SUBJECT: Second Ten Year Inservice Inspection Program

Byron Nuclear Power Station, Units 1 and 2
Facility Operating Licenses NPF-37 and NPF-66
NRC Docket Nos. 50-454 and 50-455

ATTACHMENT 1
RAI QUESTIONS AND RESPONSES

ATTACHMENT 3
REVISED RELIEF REQUESTS

FIGURE 1

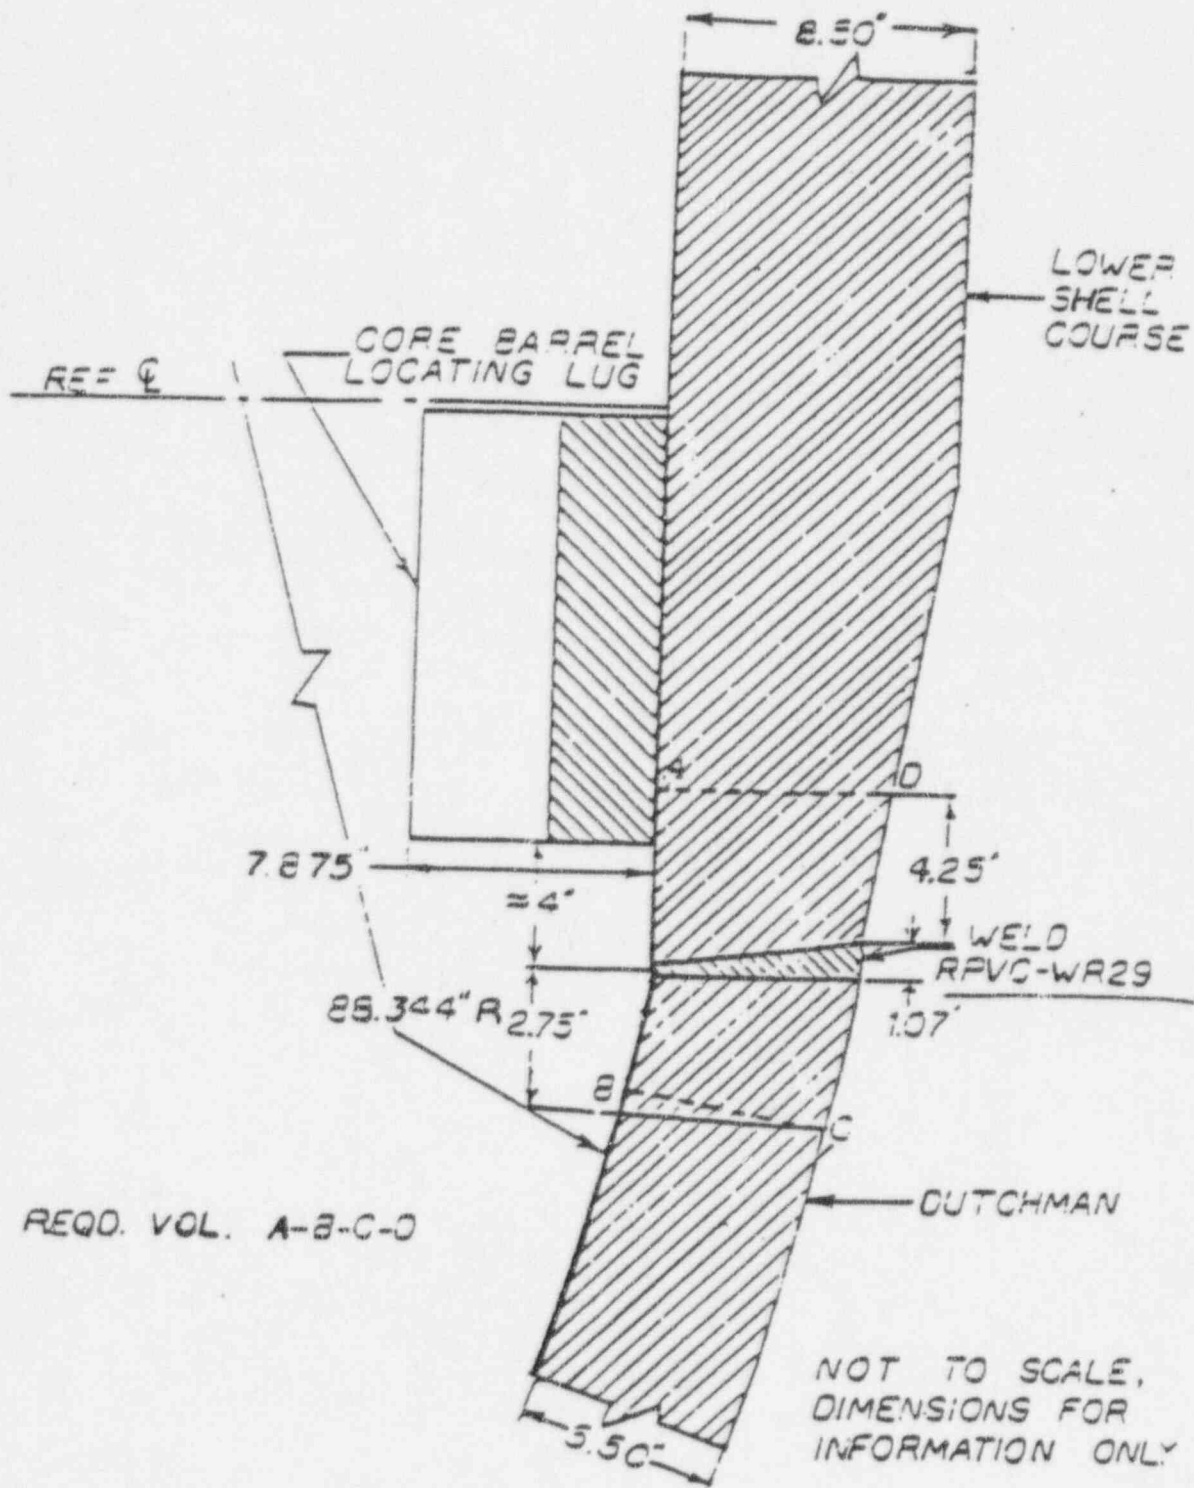
The examination of the Unit 1 Lower Shell Course-to-Dutchman weld, RPVC-WR29, is restricted by six (6) core barrel locating lugs welded to the inner surface of the vessel approximately 4 inches above the weld (See Figure 1).

These lugs obstruct the automated UT inspection tool from examining the code required volume of the weld below each lug (156°). The FTI "URSULA" tool has a 6 degree movement arm and the physical size of the lugs and the "yaw" joint of the tool prevented scanning below the lugs back into the weld and surrounding base metal. All weld metal can be examined from both sides where access is available between the lugs (204°). Examinations for perpendicular and parallel reflectors covered areas accounting for 57% of the weld metal and heat affected zone (HAZ). Similarly, 57% of the weld metal can be examined for transverse reflectors from two opposing directions.

The examination of the Unit 2 Lower Shell Course-to-Dutchman weld, RPVC-WR29, is similarly obstructed (see Figure 1). All weld metal can be examined from both sides where access is available between the lugs (204°). Examinations for perpendicular and parallel reflectors can cover areas accounting for 57% of the weld metal and heat affected zone (HAZ). Similarly, 57% of the weld metal can be examined for transverse reflectors from two opposing directions.

The ultrasonic examination of the Byron Unit 1 reactor vessel was performed to the maximum extent possible. No alternative volumetric examination is proposed to examine the areas not scanned due to obstructions or geometric constraints.

FIGURE 2

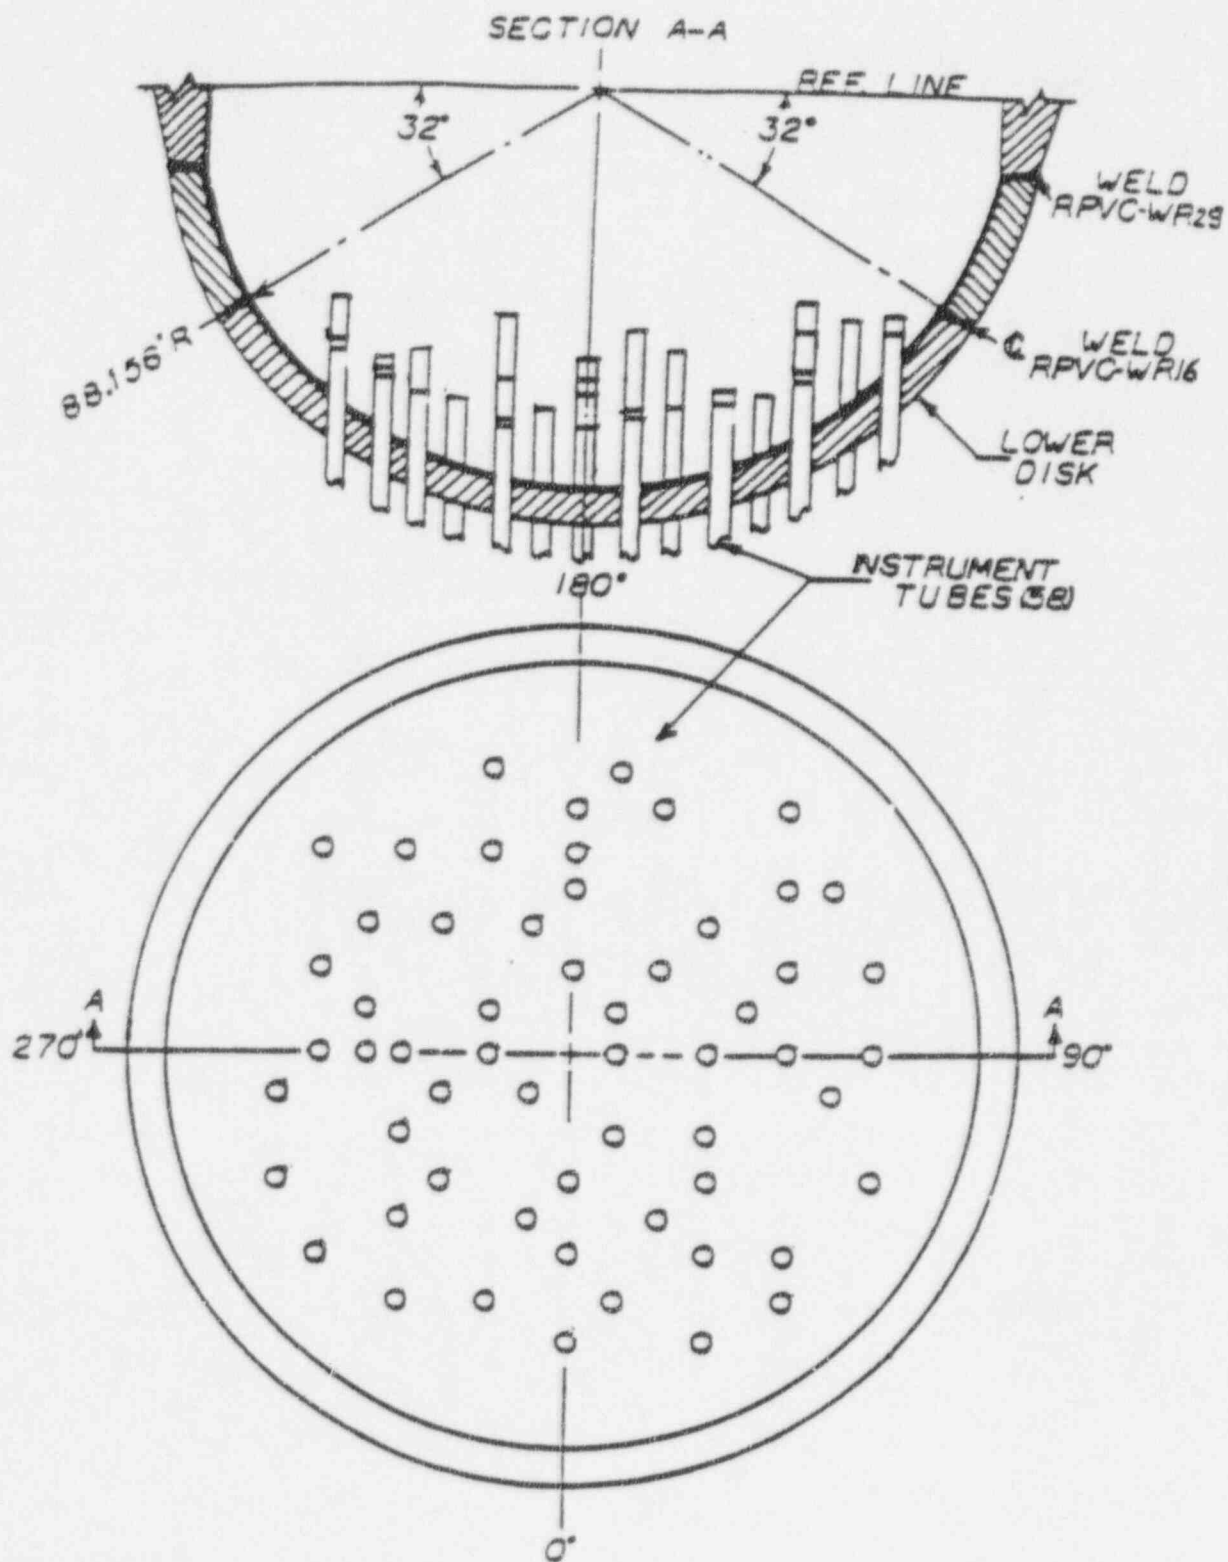
The examination of the Unit 1 Lower Disk-to-Dutchman weld, RPVC-WR16, is restricted by the 58 instrument tubes that penetrate the lower disk and physically obstruct the UT search unit and/or the search unit position device as shown in Figure 2 and 3. Approximately 19% of the weld length cannot be examined. The weld and the HAZ received essentially 100% coverage for parallel reflectors from the Dutchman side and for transverse reflectors in two opposing directions. Partial coverage is achieved for parallel reflectors from the disk side on the remainder of the weld resulting in an aggregate of all scan coverage of approximately 81%.

The examination of the Unit 2 Lower Disk-to-Dutchman weld, RPVC-WR16, is similarly restricted, see Figure 2 and 3. The weld and the HAZ will receive essentially 100% coverage for parallel reflectors from the Dutchman side and for transverse reflectors in two opposing directions. Partial coverage can be achieved for parallel reflectors from the disk side on the remainder of the weld resulting in an aggregate of all scan coverage of approximately 81%.

Figure 1

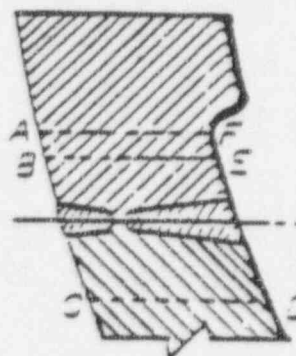
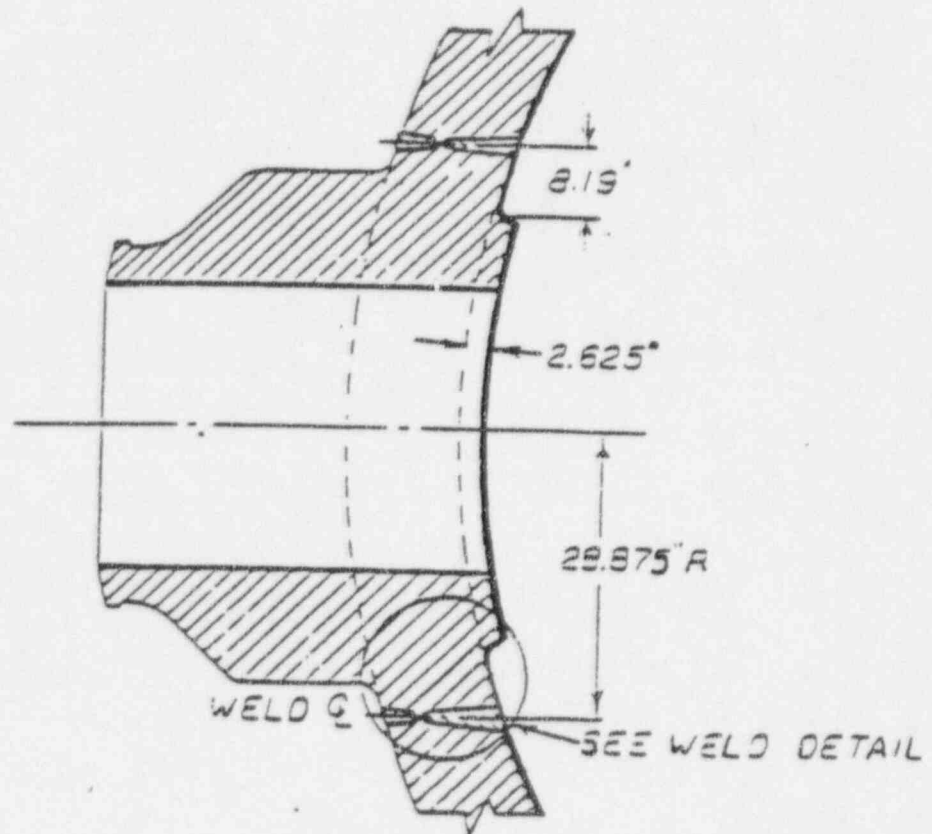
The Reactor Vessel Outlet Nozzles were designed and fabricated with an extension lip as shown in Figure 1 such that the nozzle-to-vessel welds are partially obstructed for the code required volumetric examination. This obstruction limits the circumferential scan for reflectors transverse to the weld such that 19% (aggregate) of the required volume can not be examined.

None; the Code required volumetric examination will be completed to the maximum extent practical using ultrasonic examination techniques.

FIGURE 1:
Pressurizer Lower Head Assembly

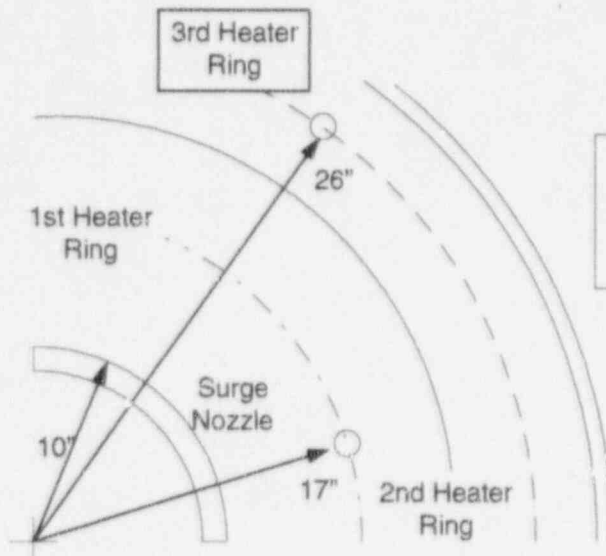
The Byron Unit 1 and 2 Pressurizers include a single surge nozzle which is welded to the lower head as shown in Figure 1. In order to perform the code required volumetric examinations on the nozzle-to-vessel weld and the nozzle inside radius section, the outer surface of the lower vessel head must be accessible for proper surface preparation and ultrasonic scanning.

As identified in the SER dated May 3, 1996, the pressurizer surge nozzle-to-vessel weld and nozzle inside radius section will be volumetrically examined if the lower head insulation is removed for any reason.

FIGURE 2:
Vessel Centerline Distance to
Surge Nozzle and
Heater Elements

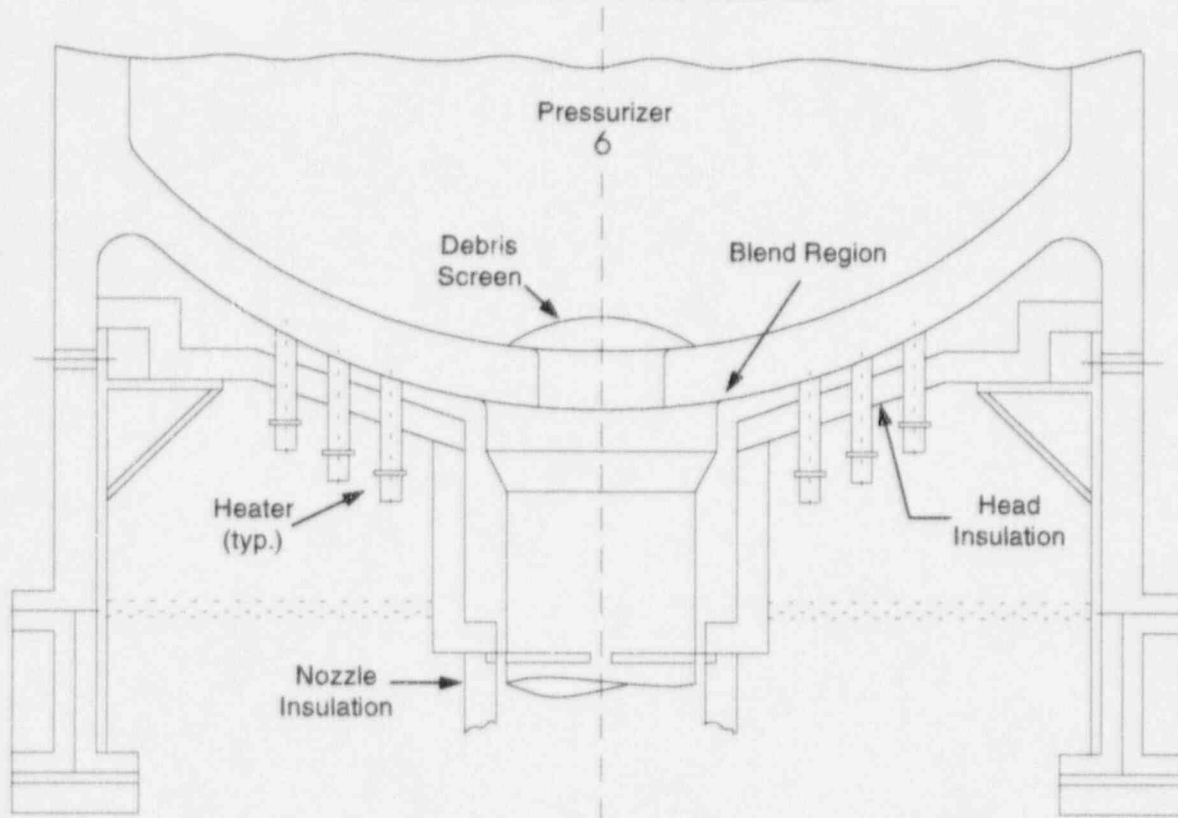
The lower head is normally covered by a 4 inch thick, multi-layered stainless steel insulation which was not designed for removal. In order to remove the insulation, the 78 heater penetration cables shown in Figure 2 would have to be disconnected. In addition, each of the 78 convection stops, which are riveted to the insulation would have to be cut to facilitate the insulation removal per Figure 3.

FIGURE 1:
RHR Vessel/Nozzle Configuration

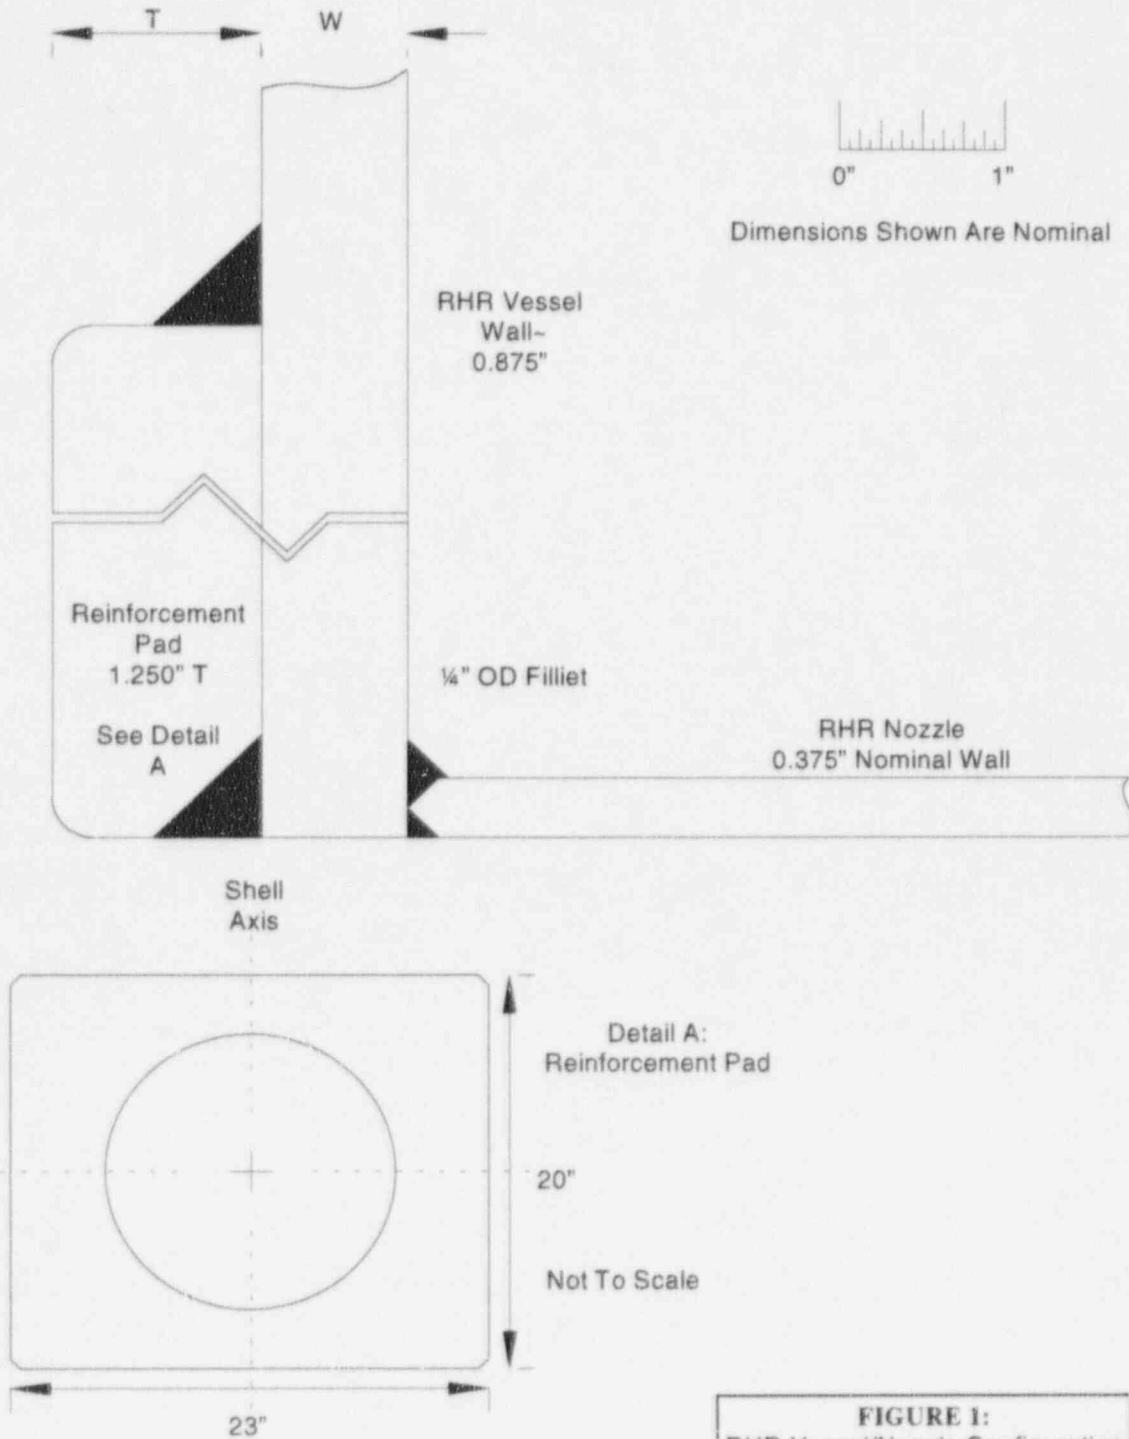
The Residual Heat Removal Heat Exchangers were fabricated with a nominal wall thickness of .875 inch and 14 inch diameter inlet and outlet nozzles which are .375 nominal wall thickness. As shown in Figure 1, the subject configuration is best characterized as a fillet welded nozzle with an internal reinforcement pad. The configuration is similar to that shown in Figure IWC-2500-4(c), except for internal location of the reinforcing pad. Because the inlet and outlet piping is welded to the subject nozzles, the inside of the RHR Heat Exchangers is not accessible as described in the "Parts Examined" text for Item No. C2.32.

Due to the geometrical constraints of this nozzle design, the ultrasonic examination of nozzle-to-vessel welds will not achieve the required 90% coverage per Code Case N-460 and Section XI, 1989 Edition. Alternatively, a "best effort" ultrasonic examination will be performed on one sample nozzle-to-vessel weld of each unit during the first period and a dye penetrant examination on each nozzle in each period for the ten-year interval. This alternative examination approach was approved for Interval 1 per NRC Safety Evaluation Report dated February 29, 1996, for Relief Request NR-18.

The Code required volumetric examination will be completed to the maximum extent practical using ultrasonic examination techniques. This technique is described above in the "Basis for Relief" section. Additionally, a surface examination will be performed on each nozzle in each Inspection Period during the 2nd Inspection Interval.

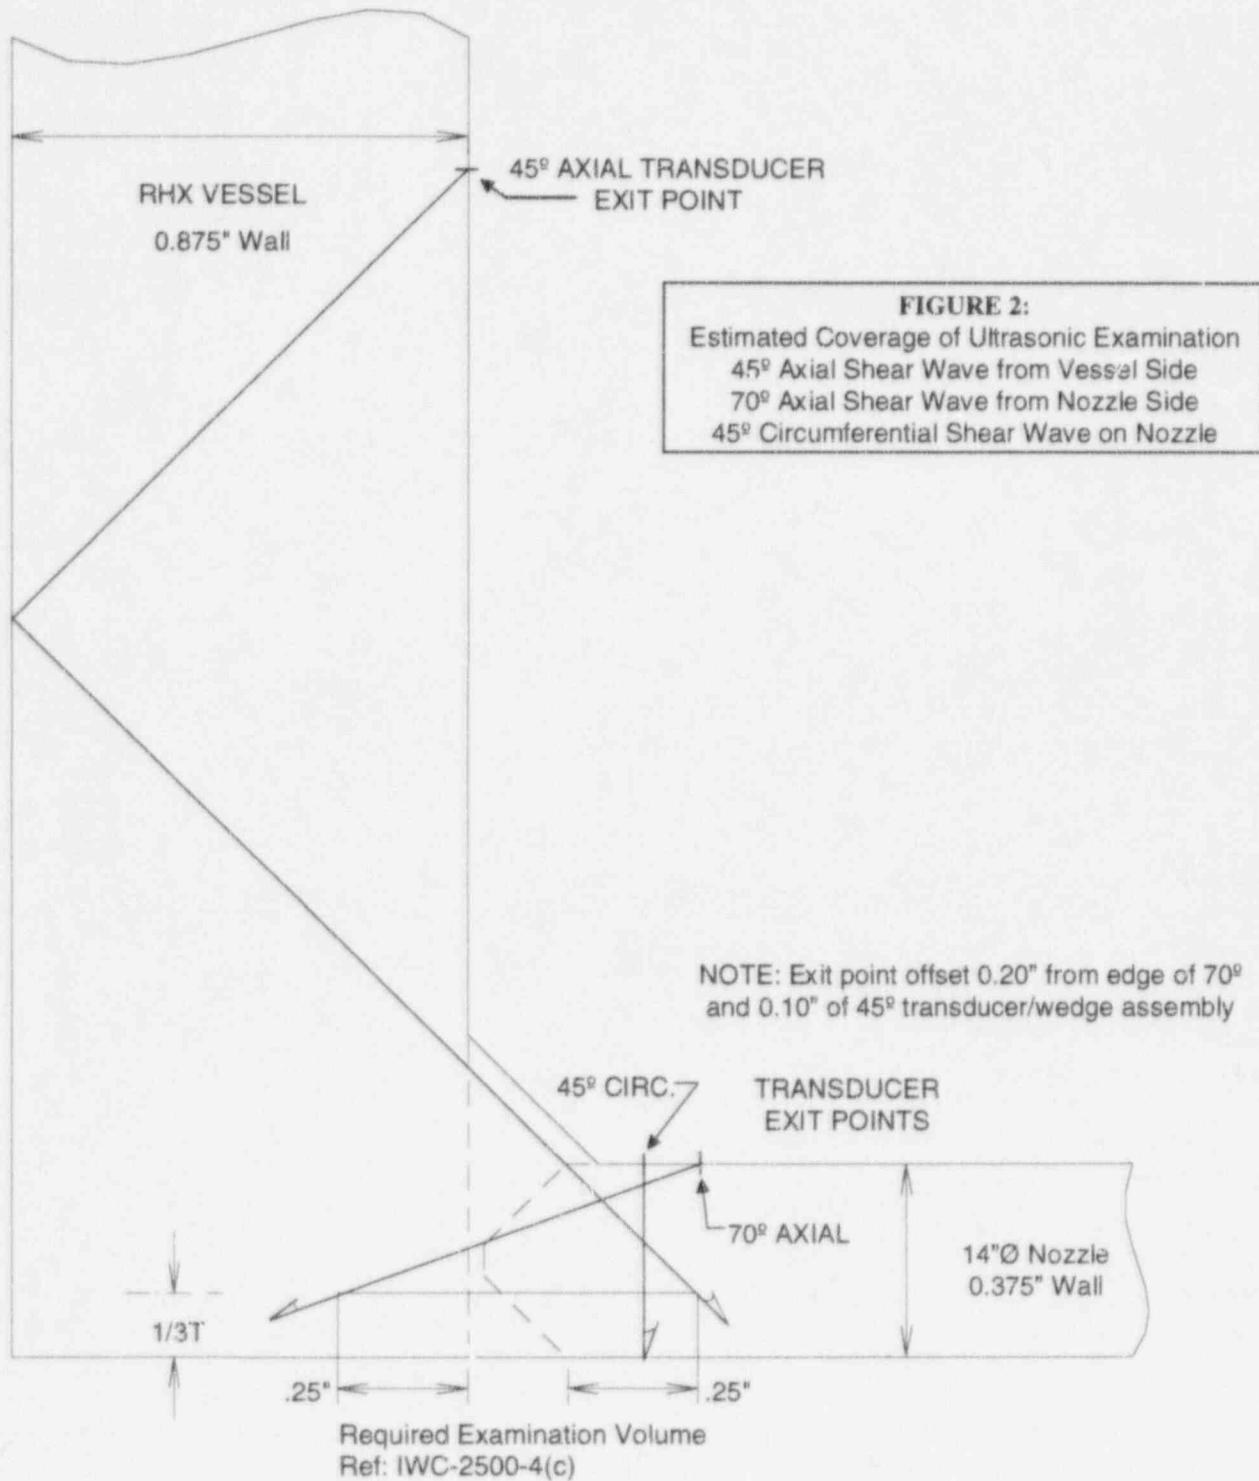
The "best effort" ultrasonic examination will primarily be performed from the nozzle outside surface. Anticipated obstructions include the reinforcement fillet weld located directly above the nozzle-to-vessel weld. This fillet weld restricts inspection transducer movement and limits available examination angles. A 70° transducer will be used on the nozzle side of the weld to pass sound under the fillet weld to reach the lower $\frac{1}{3}T$ of the pressure retaining weld. Scanning from the vessel side of the weld will be accomplished by use of a 45° shear wave transducer on the shell surface to reach the examination volume. These scans are in the axial direction of the nozzle-to-vessel weld. Scans in the circumferential direction will be very limited due to the location of the fillet weld. This weld location does not allow the transducer to scan over the entire examination volume from the outside of the nozzle. It is estimated that 99.92% of the examination volume will be reached in the axial direction. With the limited circumferential scans (13.29%), the total scanning percentage is estimated at 56.61%. See Figure 2 of this report for scan coverage plots.
